# McIntosh

**MODEL NUMBER:** MI 2

**DATE:** MARCH 1965

**MODIFICATION:** To eliminate any shape other than a dot when in the "TEST" position.

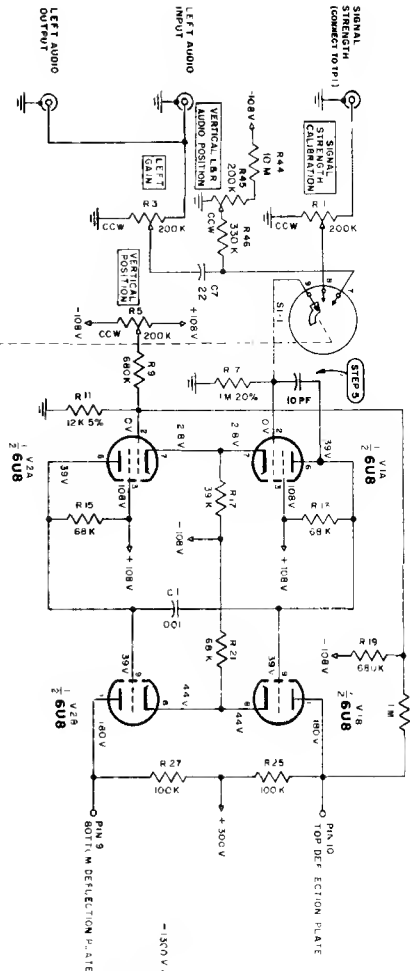
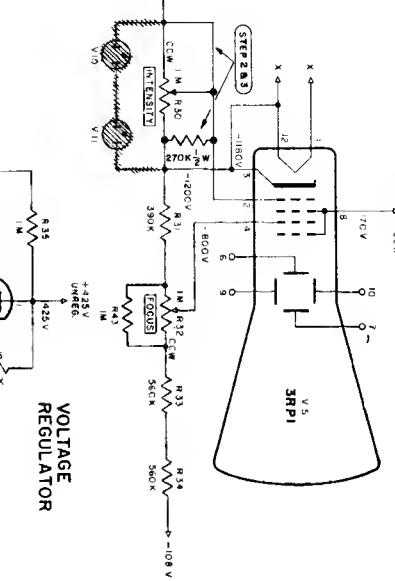
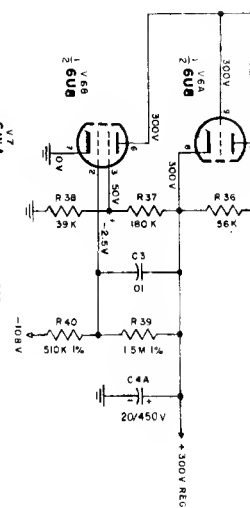
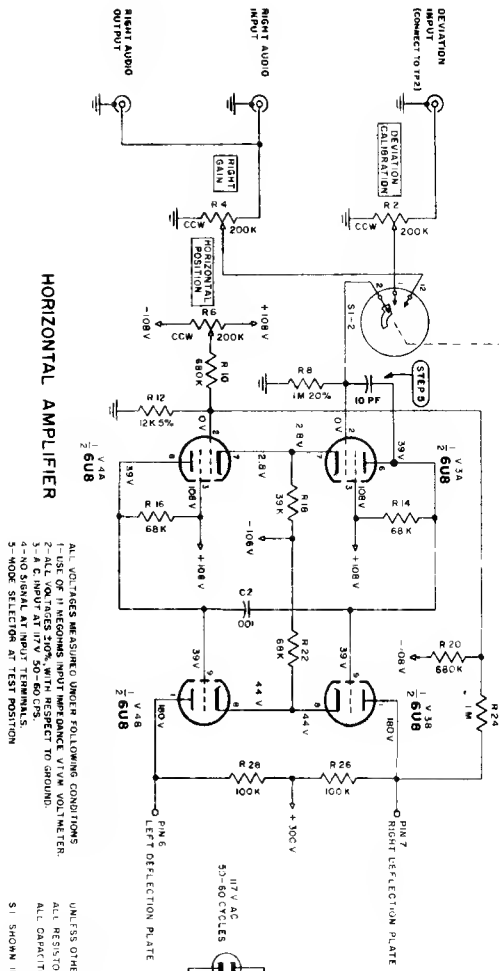
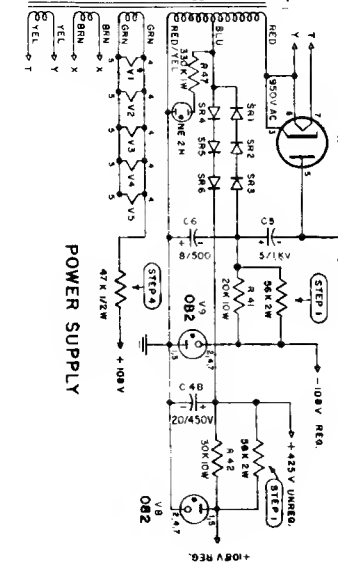
**DESCRIPTION:** This modification can be made to all MI 2's. If a configuration other than a sharply defined spot occurs this indicates possible oscillation in the deflection amplifier. Noise in the deflection amplifier can also cause this condition. Oscillation is caused by coupling between pins 1 and 2 of tubes V1 and V3. Noise can be caused by parasitic oscillations of intensity control neon bulbs and by coupling of power line noise into the + 108 volt supply via the filament winding on the power transformer. These modifications have been made to all MI 3's.

1. There are two 10 w resistors under the chassis, parallel each of these with a 56K 2 w resistor.
2. Remove the neon bulb from the intensity control.
3. Add a 270K ½ w resistor from the center lug of the intensity control to the side lug (at junction of yellow/white wire and 390 K resistor). Add a jumper wire from the center lug of the control to the other lug (junction of orange/white wires).
4. Remove the red/white wire from pin 5 of the 6U8 (6) to pin 1 of the OB 2 (V8). Replace the wire with a 47K ½ w resistor.
5. Add a 10pf capacitor from pin 2 to pin 6 of tubes V1 and V3. Bend the tube socket of pins of tubes V1 and V3 so that pin 1 is as far away from pin 2 as possible. Dress the leads connecting to these pins for maximum separation.

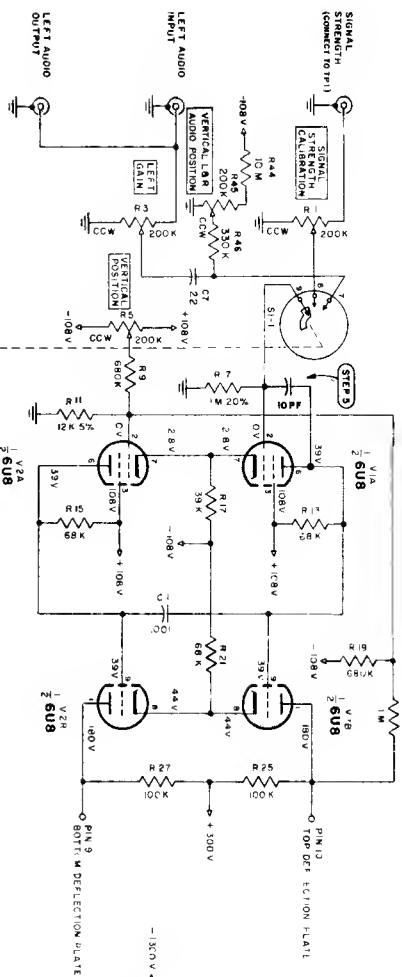
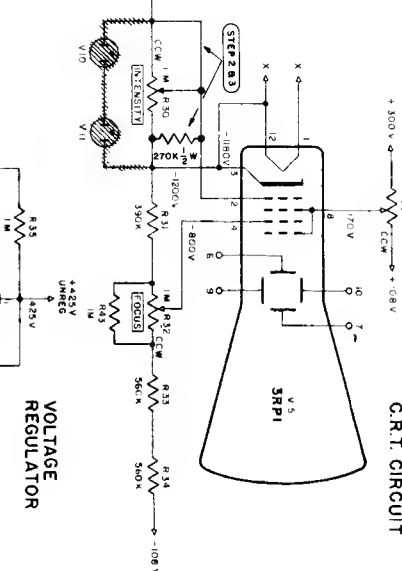
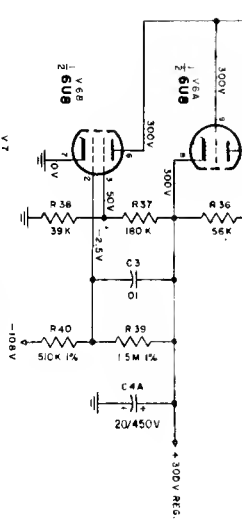
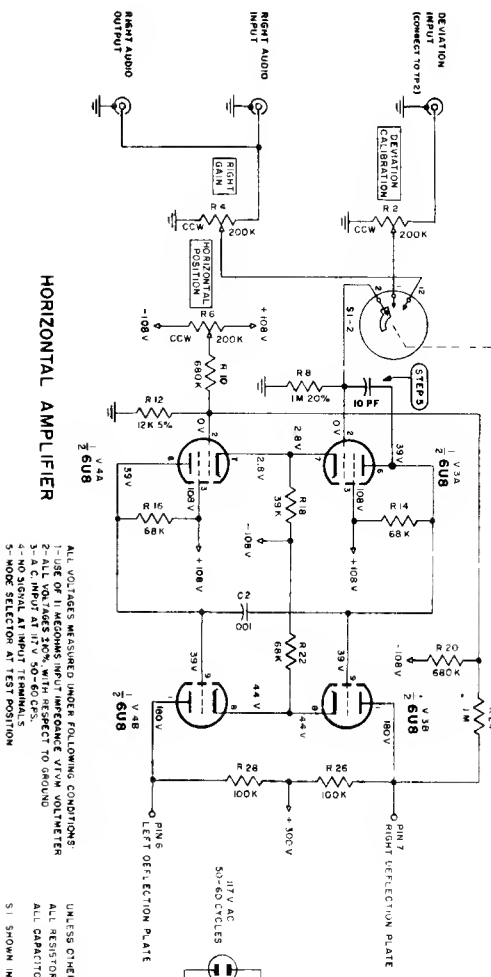
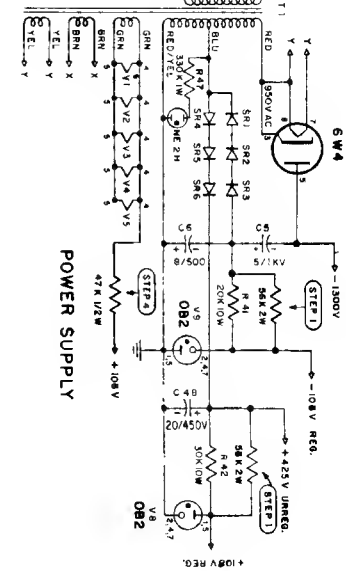
**MODIFICATION:** To eliminate any shape other than a dot when in the "TEST" position.

**DESCRIPTION:** This modification can be made to all MI 2's. If a configuration other than a sharply defined spot occurs this indicates possible oscillation in the deflection amplifier. Noise in the deflection amplifier can also cause this condition. Oscillation is caused by coupling between pins 1 and 2 of tubes V1 and V3. Noise can be caused by parasitic oscillations of intensity control neon bulbs and by coupling of power line noise into the + 108 volt supply via the filament winding on the power transformer. These modifications have been made to all MI 3's.

1. There are two 10 w resistors under the chassis, parallel each of these with a 56K 2 w resistor.
2. Remove the neon bulb from the intensity control.
3. Add a 270K ½ w resistor from the center lug of the intensity control to the side lug (at junction of yellow/white wire and 390 K resistor). Add a jumper wire from the center lug of the control to the other lug (junction of orange/white wires).
4. Remove the red/white wire from pin 5 of the 6U8 (6) to pin 1 of the OB 2 (V8). Replace the wire with a 47K ½ w resistor.
5. Add a 10pf capacitor from pin 2 to pin 6 of tubes V1 and V3. Bend the tube socket of pins of tubes V1 and V3 so that pin 1 is as far away from pin 2 as possible. Dress the leads connecting to these pins for maximum separation.
